### APPEAL SUMMARY

<b>Appeal ID:</b> 27624	<b>Project Address:</b> 4037-4039 N Williams Ave
<b>Hearing Date:</b> 3/30/22	<b>Appellant Name:</b> Mike Perso
<b>Case No.:</b> B-011	<b>Appellant Phone:</b> 503-841-5239
<b>Appeal Type:</b> Building	<b>Plans Examiner/Inspector:</b> Robert Keal
<b>Project Type:</b> commercial	<b>Stories:</b> 4 <b>Occupancy:</b> R-2, S-1, M <b>Construction Type:</b> V-A
<b>Building/Business Name:</b>	<b>Fire Sprinklers:</b> Yes - throughout
<b>Appeal Involves:</b> Erection of a new structure	<b>LUR or Permit Application No.:</b> 21-064088-CO
<b>Plan Submitted Option:</b> pdf [File 1] [File 2] [File 3]	<b>Proposed use:</b> multifamily residential, retail

#### Appeal item 1

WILLIAMS 40

01 FLOOR PLAN LEVEL 1  
1/4" = 1'-0"

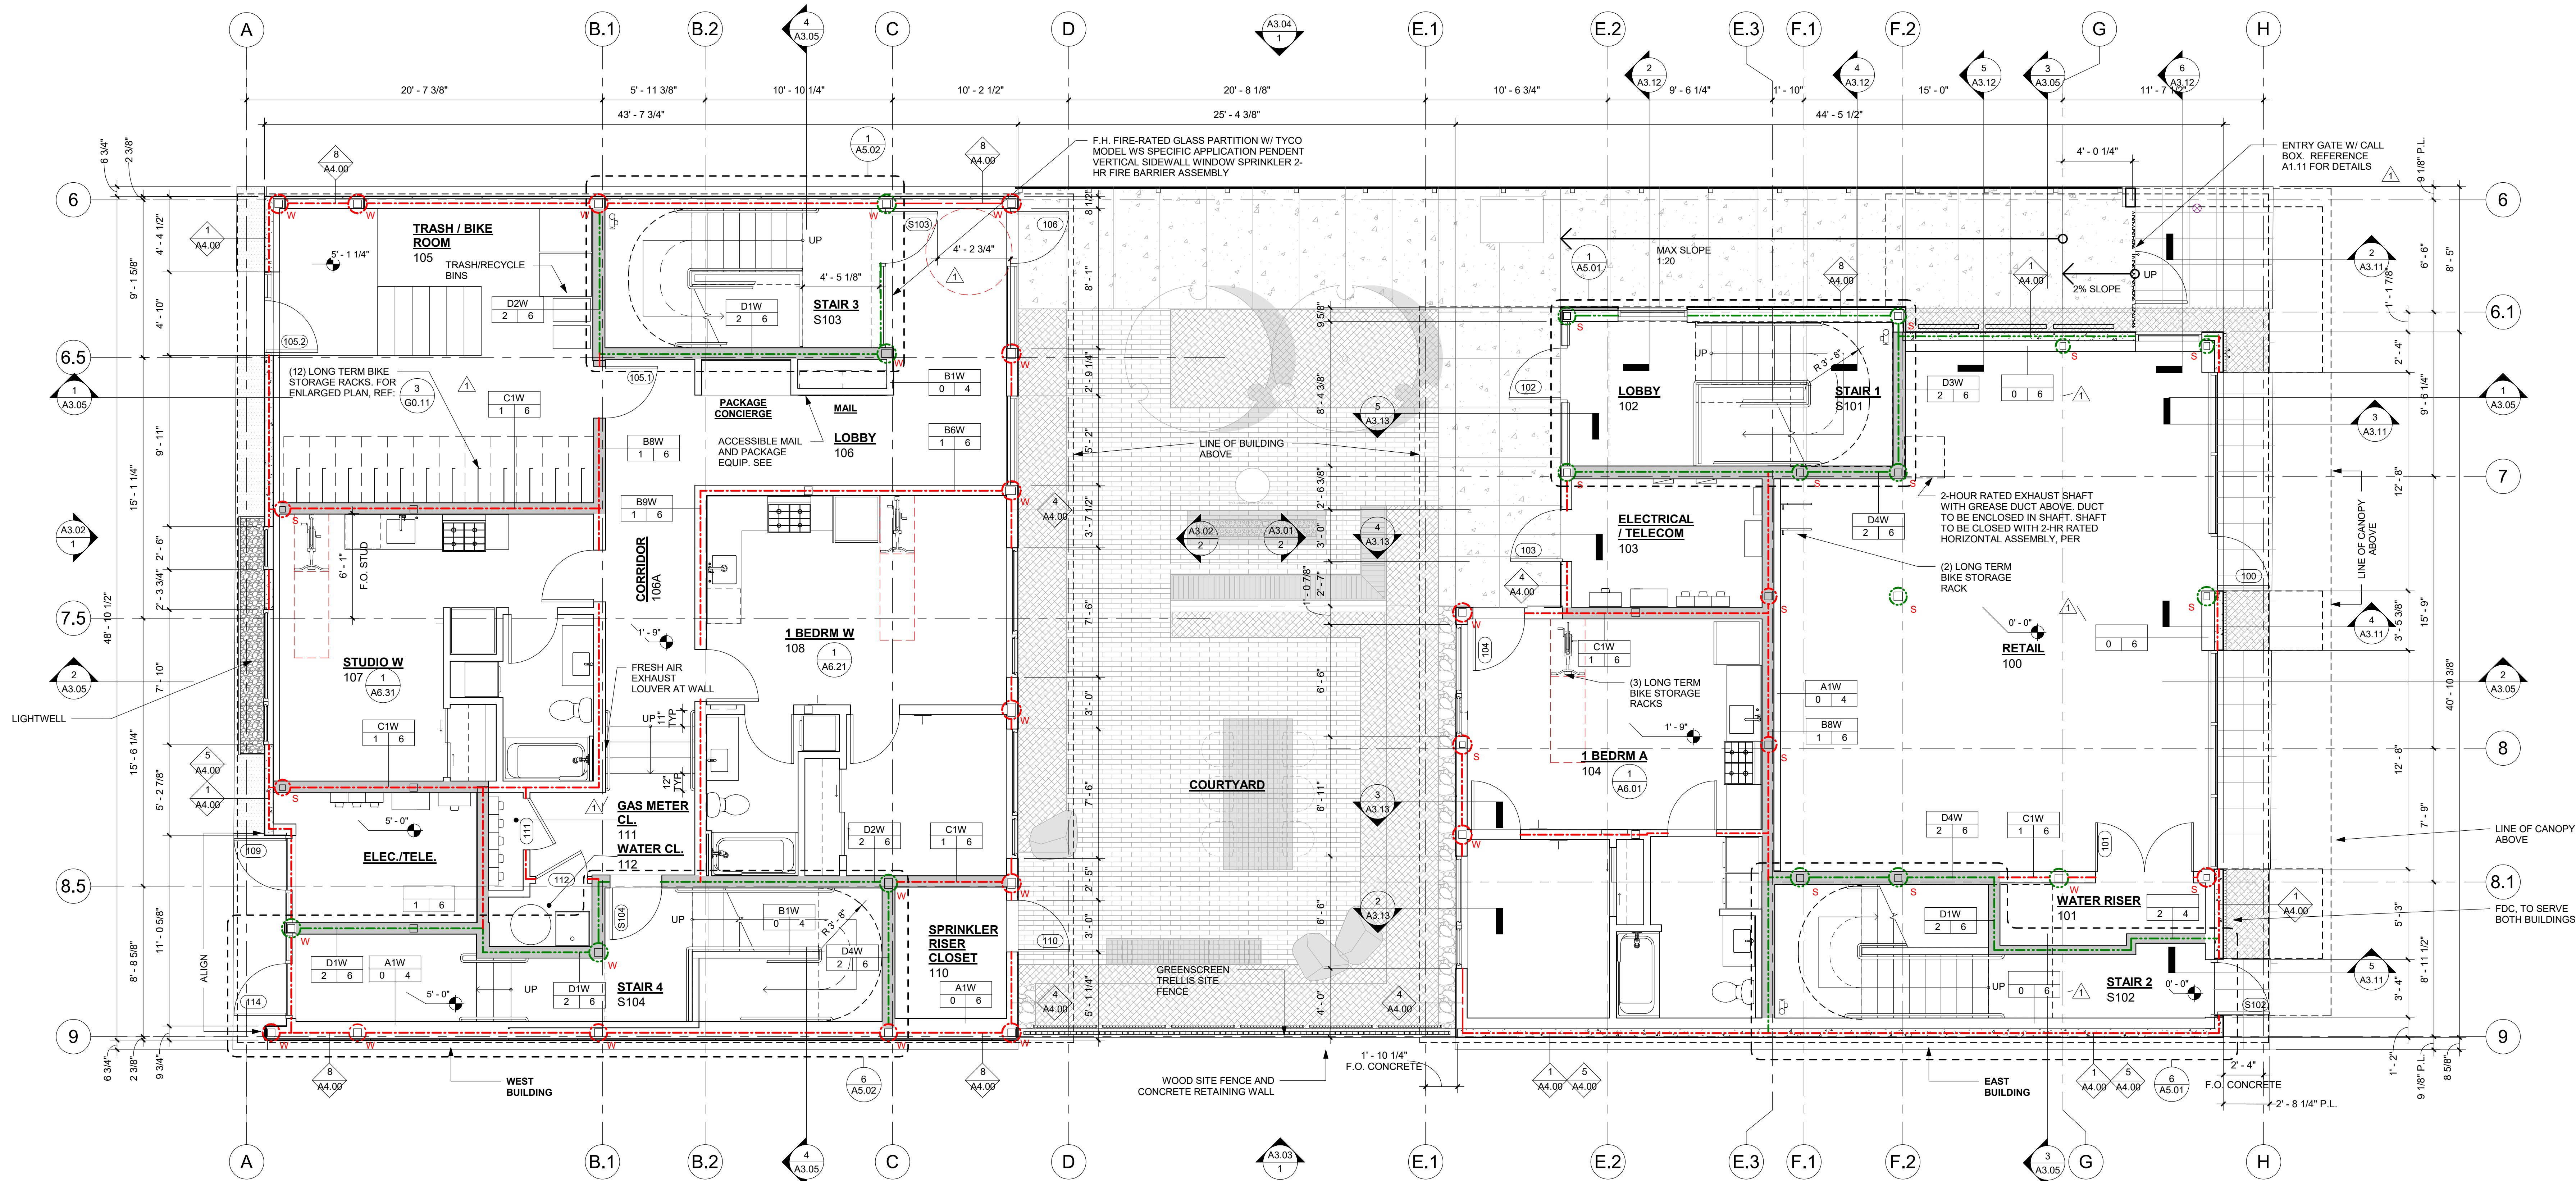
**Code Modification or Alternate Requested** This appeal requests that the path of egress travel be permitted to pass underneath the cantilevered building overhang after initially exiting the building and before discharging to a public way.

The egress court is open to the sky with the exception of a portion adjacent to ground floor retail where the exit discharge passes under building overhang and, while enclosed by building on only two sides, is considered to be reentering the building. The egress path continues under building overhang for 22 feet until it terminates at the sidewalk on N Williams Ave. The area under the overhang is proposed to be a paved walkway with a small planting strip. The bottom of the soffit at the overhang is approximately 12'-0" above the walking surface.

The fire resistance rated construction of the exterior wall along the egress court, including the portion of wall supporting the projection above is proposed to be increased to a 2-hour rating. Similarly a 2-hour rated horizontal assembly is proposed at the floor that overhangs the egress path. The entire building, including the path of exit discharge beneath building overhang in the courtyard, is fully sprinklered per NFPA 13. As an additional measure of protection, a moderate fire sprinkler hazard classification is proposed throughout the entire ground floor level and overhang. Openings at the Stair 1 landing and Retail space will be 45-minute rated openings.

**1. Exit discharge beneath building overhang: Granted provided Tyco sprinkler protection is installed in accordance with manufacturer's specifications.**

01 LIFE SAFETY SITE PLAN  
1" = 10'-0"

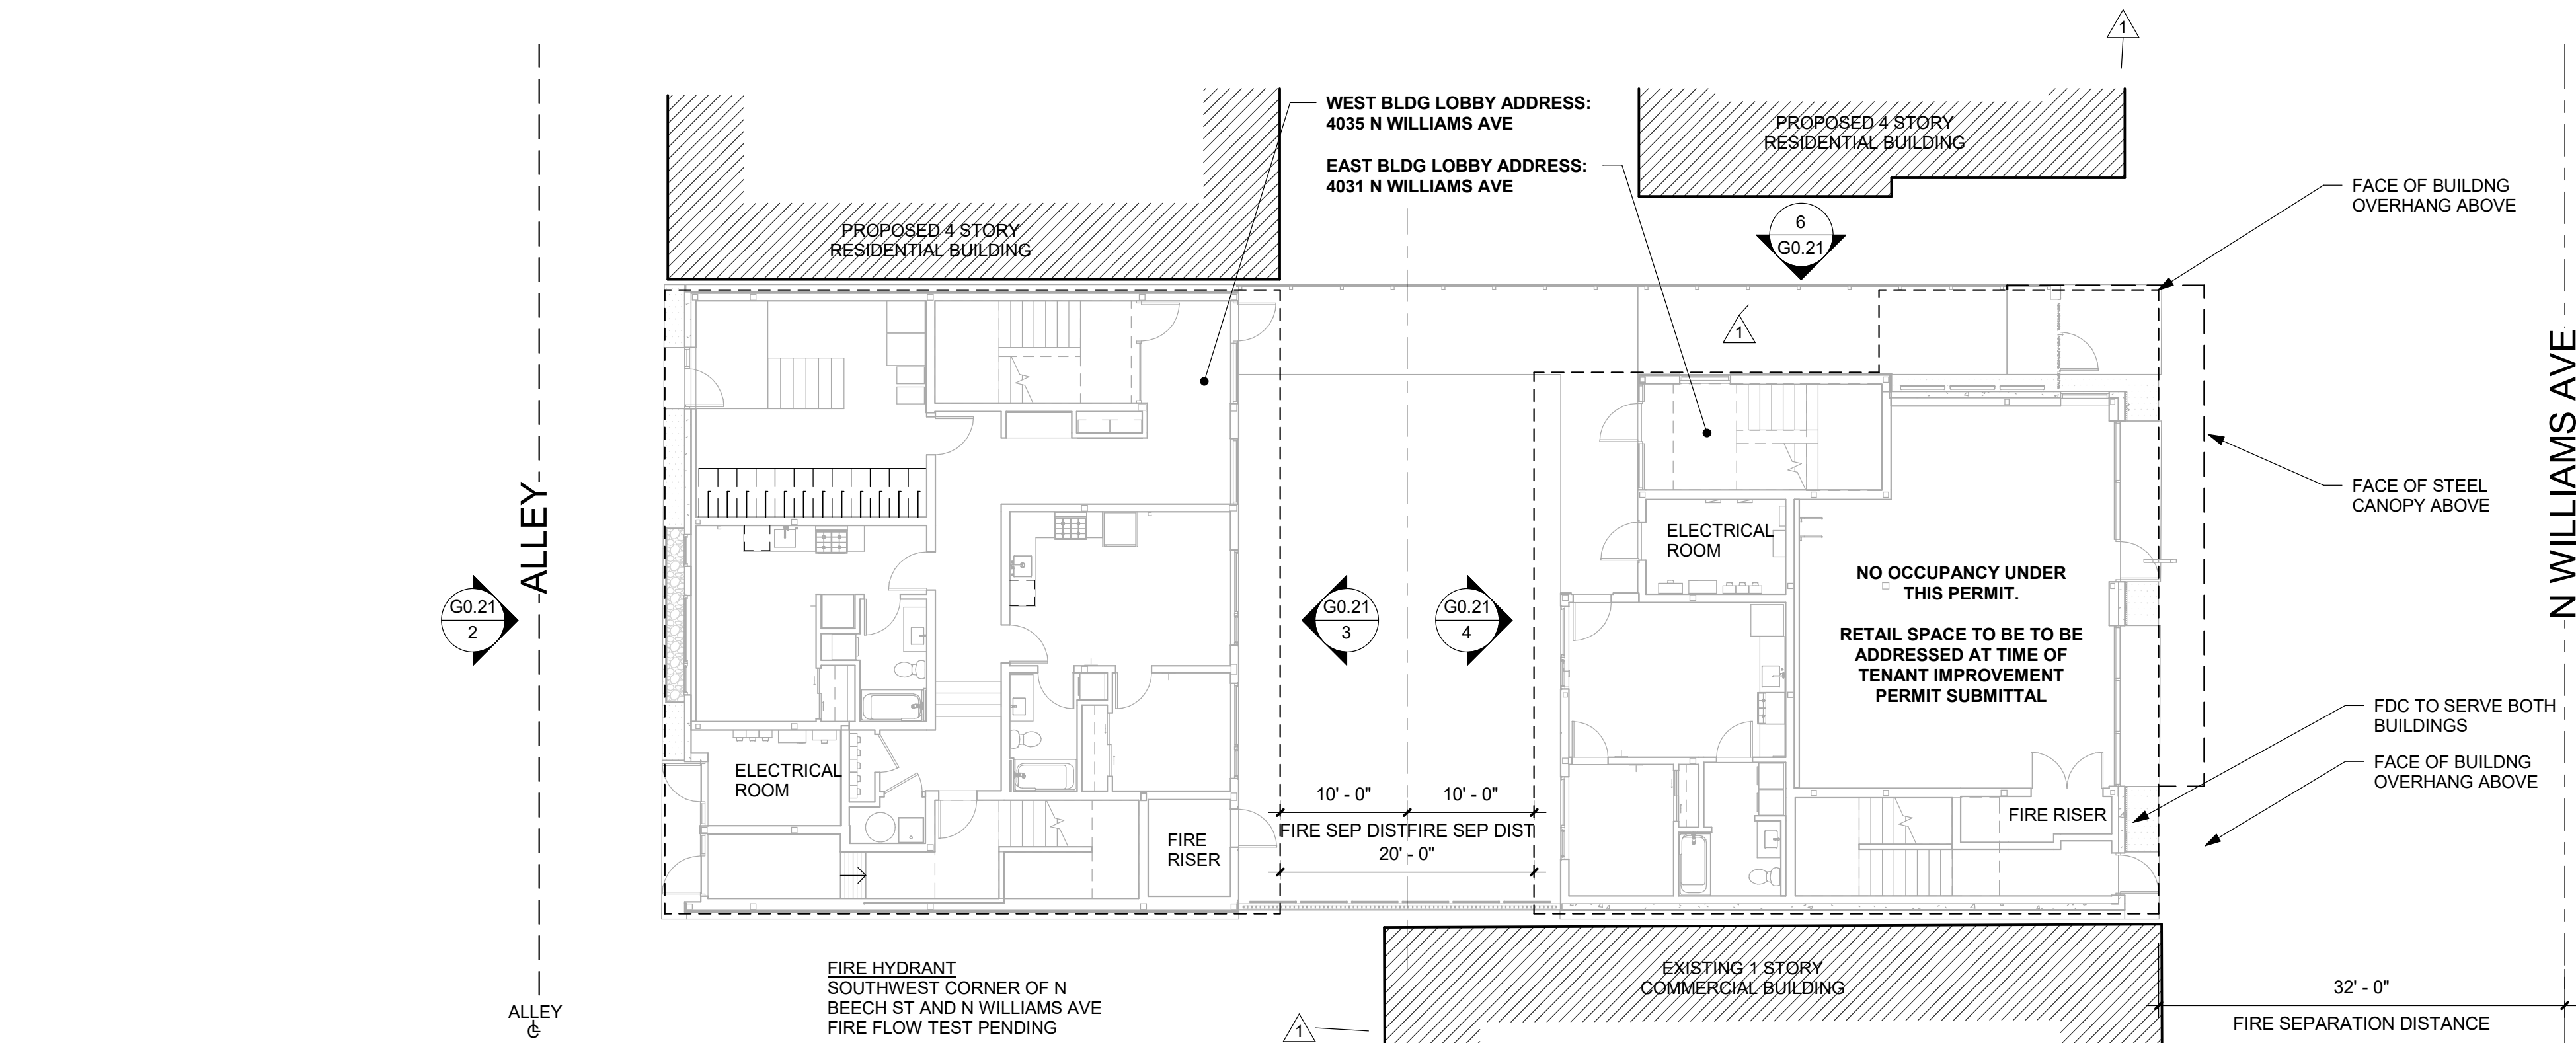
Each building has two internal exit stairs, one that discharges directly to the building exterior at a public way (Stair 2 and Stair 4), and another that exits through the shared courtyard (Stair 1 and Stair 3). An egress court along the north lot line serves as the exit discharge component of the means of egress for both Stair 1 & Stair 3. It extends between the courtyard and the termination of the exit at the public way.

<b>Code Modification or Alternate Requested</b>	This appeal proposes that the open egress court below a cantilevered portion of the building not be considered enclosed by an exterior wall, and thus not be subject to table 705.8.
<b>Proposed Design</b>	<p>As described in Appeal item 1, both East and West buildings have one exit stair that discharges through an egress court along the north lot line. A portion of the egress path continues under building overhang for 22-feet until it terminates at the sidewalk. The area under the overhang is proposed to be a paved walkway with a small planting strip, not enclosed by an exterior wall to the north. The bottom of the soffit at the overhang is approximately 12'-0" above the walking surface.</p> <p>The fire resistance rated construction of the exterior wall along the egress court, including the portion of wall supporting the projection above is proposed to be increased to a 2-hour rating. Similarly a 2-hour rated horizontal assembly is proposed at the floor that overhangs the egress path. The entire building, including the path of exit discharge beneath building overhang in the courtyard, is fully sprinklered per NFPA 13. As an additional measure of protection, a moderate fire sprinkler hazard classification is proposed throughout the entire ground floor level and overhang. Openings at the Stair 1 landing and Retail space will be 45-minute rated openings.</p>

**2. Determination of exterior wall location and exemption of opening protection requirements of Table 705.8: Granted as proposed.**
